**Request for Additional Information No. 553, Supplement 2**

**U. S. EPR Standard Design Certification**

**Docket No. 52-020**

**Question 06.03-18:****Open Item****Follow-up to RAI 416, Question 6.3-15**

**Figure 06.03-18-1–IRWST Liquid Temperature**

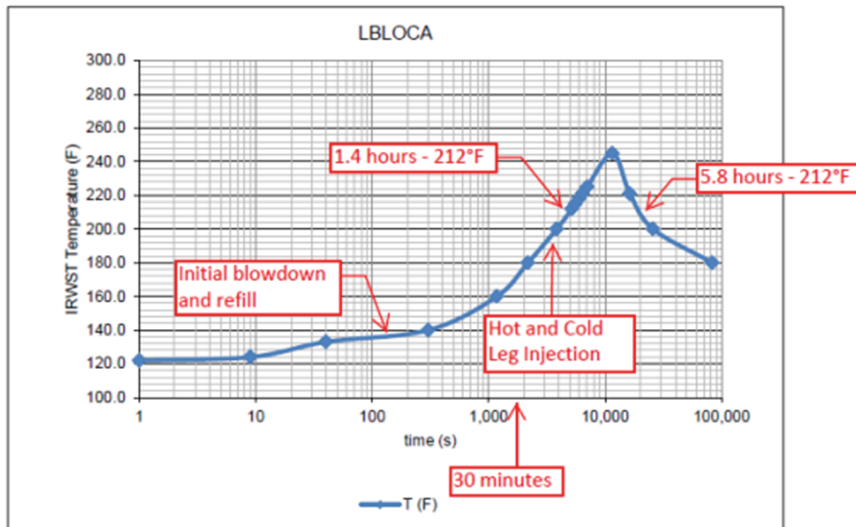
To complete the staff evaluation of the 6.3 SER Phase 2 Open Item 06.03-15 in support of ECCS pump performance, the staff request that AREVA address guidance contained in SECY 11-0014 and provide key NPSH information in FSAR section 6.3 that identifies the limiting or worst case NPSH evaluation for the ECCS pumps with justification for the selected data. At a minimum, the staff expects the FSAR to contain the limiting ECCS pump NPSH evaluation, to include the following parameters and plots, and to specify the basis for the ECCS pump flowrate selected and NPSH<sub>r</sub> uncertainty. Note, all heads and pressures should be expressed in feet of liquid at the pumping temperature selected for the evaluation.

To facilitate understanding of the post-LOCA (loss of coolant accident) sequence of events, the heatup and subsequent cooldown of the in-containment refueling water storage tank (IRWST) is shown in Figure 06.03-18-1—IRWST Liquid Temperature for the large break loss of coolant accident (LBLOCA).

After the initial blowdown and refill, decay heat increases IRWST temperature until the heat removal rate of the LHSI heat exchangers matches the rate of decay heat as shown in Figure 06.03-18-1. The head equivalent to the vapor pressure of the water varies with temperature. U.S. EPR FSAR Tier 2, Section 6.3.3.3, NPSH Evaluation, will be revised to provide additional description of the evaluation of the NPSH<sub>a</sub> during this period.

The first part of the NPSH evaluation considers the period without operator action as the IRWST heats up and then the interval in the low NPSH margin range that is approximately two hours for LHSI. Therefore, the time of greatest susceptibility to cavitation erosion is very limited. Figure 06.03-18-1 shows that IRWST temperatures were above 200°F for approximately six hours.

Figure 6.3-8—LHSI in LB LOCA

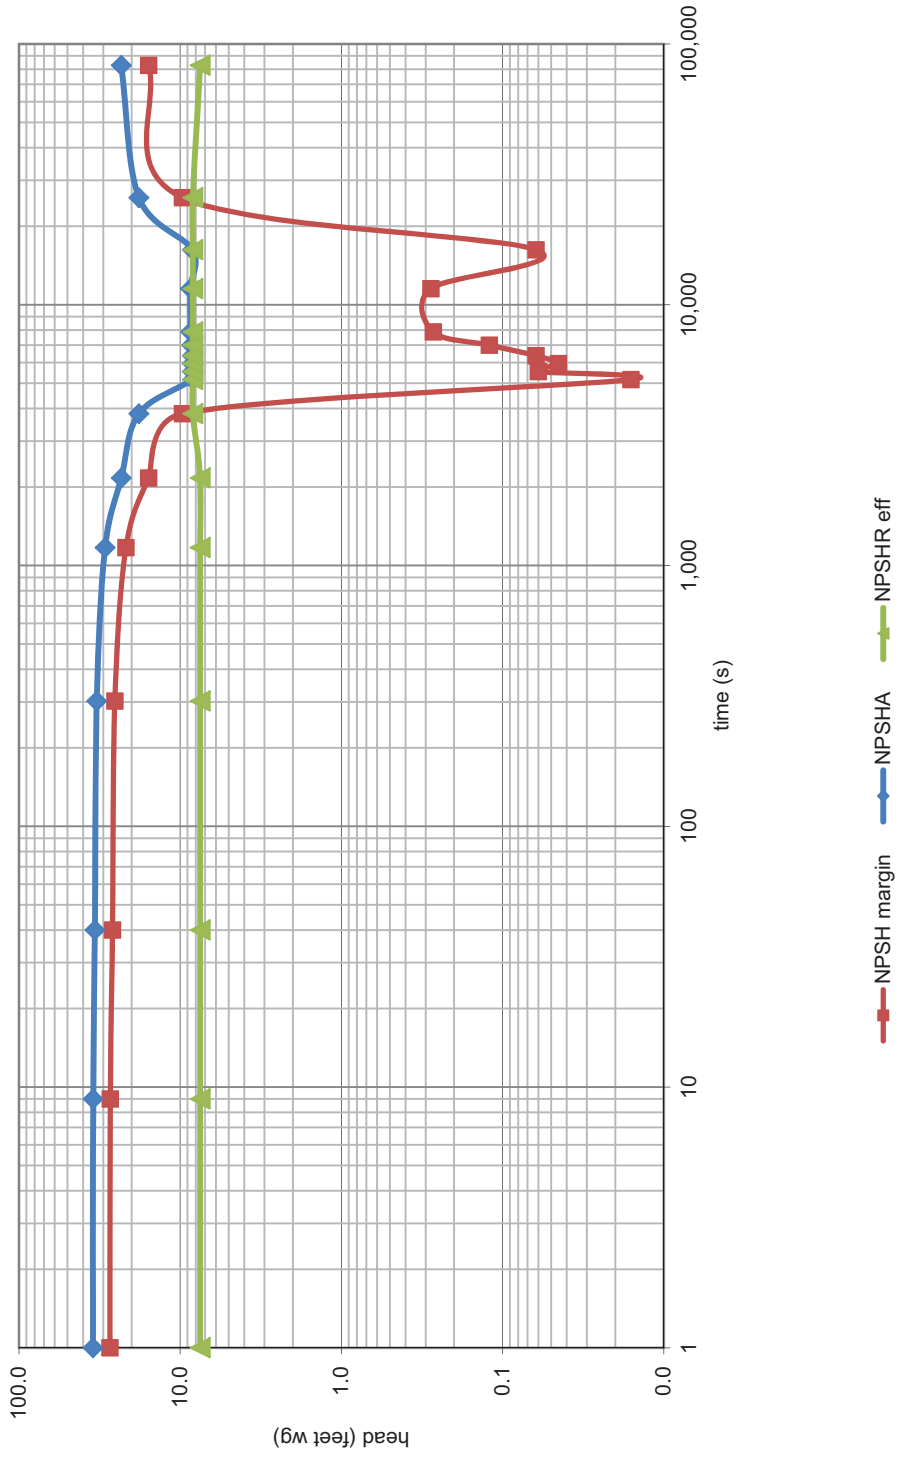
- Line/friction loss (feet)
- Atmosphere Pressure (feet)
- Vapor Pressure of liquid at pump suction (feet)
- NPSH<sub>reff</sub> where  $NPSH_{reff} = (1 + \text{uncertainty}) \times NPSH_r \times 3\%$
- Plot of NPSH<sub>a</sub> and NPSH<sub>reff</sub> vs. Time

New U.S. EPR FSAR Tier 2, Figure 6.3-8—LHSI in LB LOCA and Figure 6.3-9—MHSI in LB LOCA, will be provided to show NPSH over time for the LHSI and MHSI pumps, respectively.

Generic pump tests indicate that the zone of maximum cavitation erosion rate lies between NPSH margin ratios of 1.2 to 1.6 according to NRC SECY-11-0014. The NPSH margin over time where NPSH ratio is between 1.2 and 1.6 are shown in new U.S. EPR FSAR Tier 2 Figure 6.3-8 and Figure 6.3-9.

Large NPSH margin exists during the blowdown and refill phases, as shown in U.S. EPR FSAR Tier 2, Figure 6.3-8—LHSI in LB LOCA and Figure 6.3-9—MHSI in LB LOCA. At approximately one hour into the event operator action to align LHSI flow, required for simultaneous cold-leg and hot-leg injection and stop MHSI flow, is taken to limit pump runoff. This corresponds to the slightly positive LHSI pump NPSH margin.

Note: The NPSH Margin and NPSHA curves in U.S. EPR FSAR Tier 2, Figure 6.3-8 exhibits what appears to be a slight discontinuity around 2000 seconds. This apparent discontinuity has been evaluated and verified to result from the Excel curve plotting application attempting to plot a smooth curve on a log-log scale plot. There is no data error associated with this plot.

The most limiting case for NPSH for the LHSI pump is 2925 gpm during simultaneous injection, saturated liquid in the IRWST, and saturation pressure both in containment and at the break at 212°F as shown in Figure 6.3-8—LHSI in LB LOCA. For this case, the MHSI pump is switched off so the LHSI pump discharge flow rate equals the total suction flow rate. The results are:

$$\text{LHSI NPSH Margin} = 0.02 \text{ ft or } 0.2 \text{ percent}$$
